May 8, 2013

TO: Members of the MAG Building Codes Committee

SUBJECT: MEETING NOTIFICATION AND TRANSMITTAL OF TENTATIVE AGENDA

TENTATIVE AGENDA
MAG Building Codes Committee Meeting
May 15, 2013

FIGURE R602.3(2)
FRAMING DETAILS

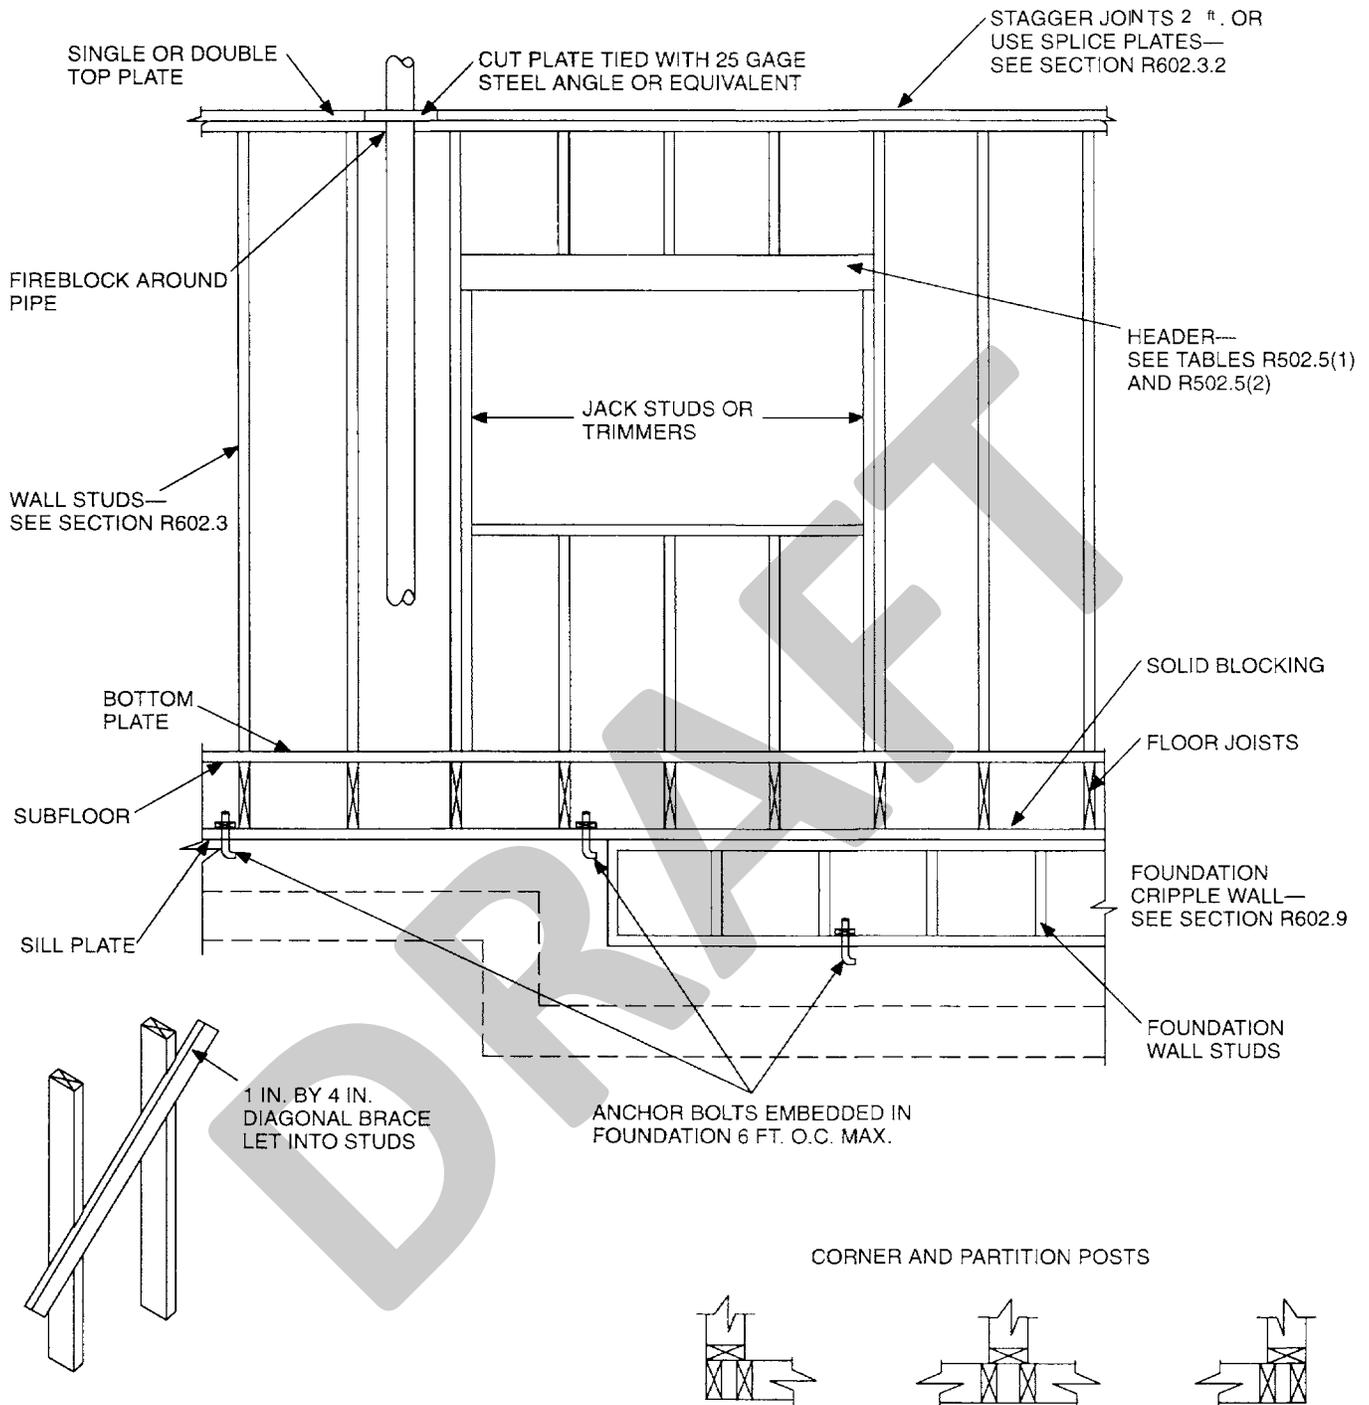
Revision to: Section 602.3 and Figure R602.3 (2)

Proposal: Figure R602.3 (2) Framing Details The note in the upper right corner of the page is edited to read “STAGGER JOINTS ~~24~~ ft IN. OR USE SPLICE PLATES—SEE SECTION R602.3.2”.

The remainder of the figure is to remain unchanged.

Reason: Section R602.3.2 states, “End joints in top plates shall be offset at least 24 inches (610 mm).” By revising the Figure, the information is consistent with the text of the code.
